# of Conflict checking of BOTTOM LEVEL ACCESS PLATFORMS (SECTOR 13)

Done by Lasha Sharmazanashvili 17/03/2005

AT392123MQ — BOTTOM LEVEL ACCESS PLATFORMS (SECTOR 13) with Toroid Magnets, Muon Spectrometer, Services and Support Structure.

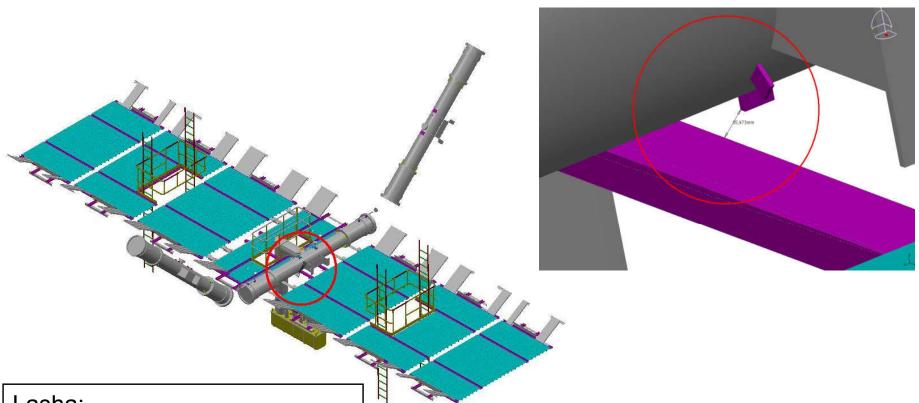
Liudmila Cross-out this conflict without any comments. I remain it as RELEVANT to pay attention of integration team Critical distance with value =36mm Sector 13, Side C

#### AT392123MQ - NTB $\_0007$ (TB FEET COIL - SECTOR 14 )

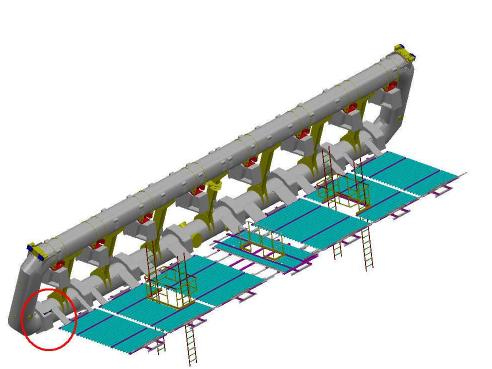
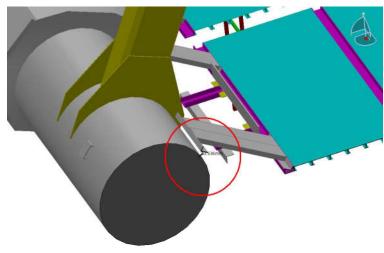
Mobile part

Critical distance with value =34mm Sector 14, Side C

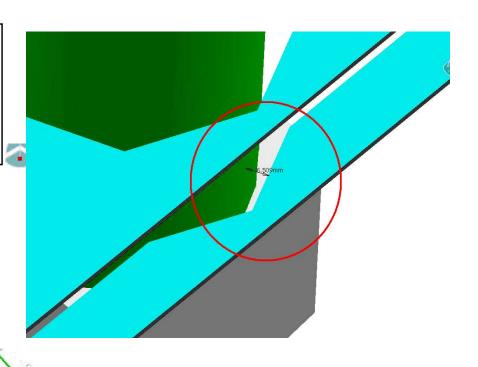
Central part to be configured after service Z0 designed (Denis)

I remain it as RELEVANT while conflict is not with Z0 services but with Barrel projective Alignment

Critical distance with value =6.5mm Sector 13, Side C

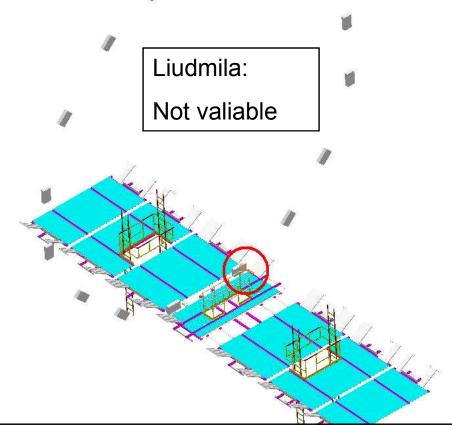
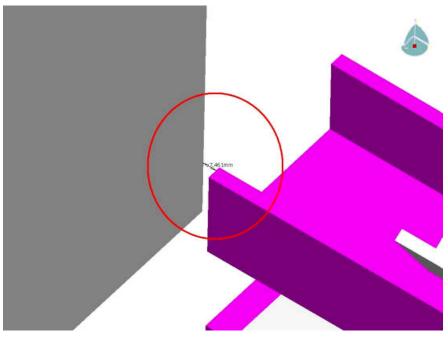
Liudmila Cross-out this conflict while as she told me she suggest other solution regarding boxes. I remain it as RELEVANT to pay attention of integration team Critical distance with value =7.46mm Sector 13, Side A

#### $AT392123MQ\ /\ NSM\_0016\ (\text{HEATER CABLE DISTRIBUTION - FOR FOOT REGION}\ )$

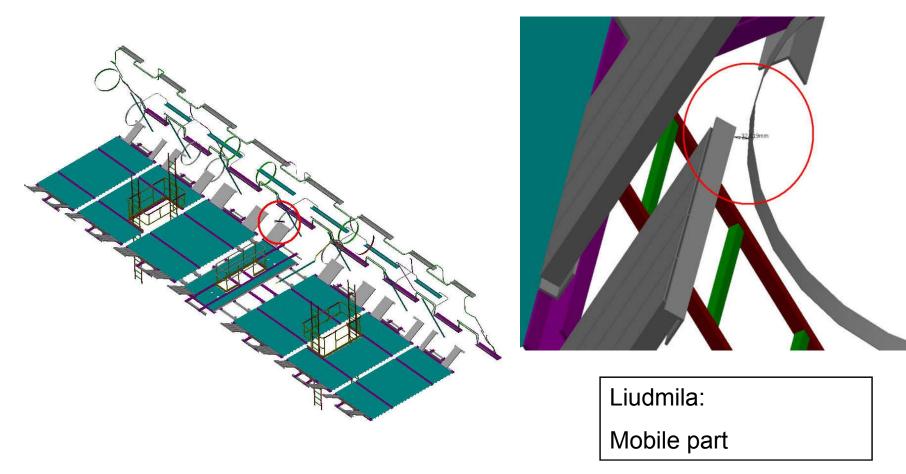
Critical distance with value =32.6mm Sector 13, Side A

#### AT392123MQ / NSR\_0007 (CABLE SERVICE - CABLE TRAYS)

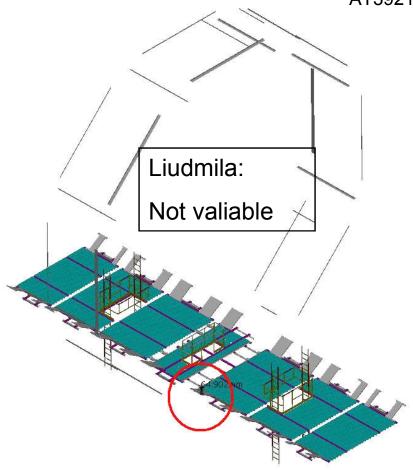
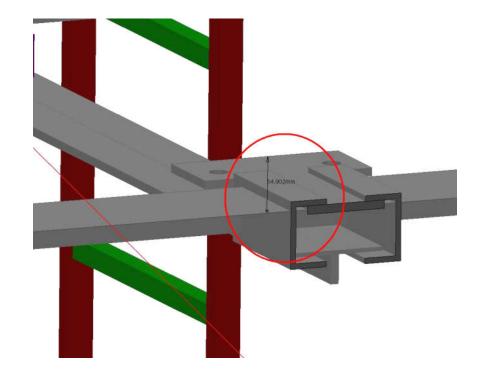
NSR\_0007 is really old coming from ELEONORA SELETSKAIA and dated by 25-AUG-2003

Clash with value =65mm Sector 13, Side C
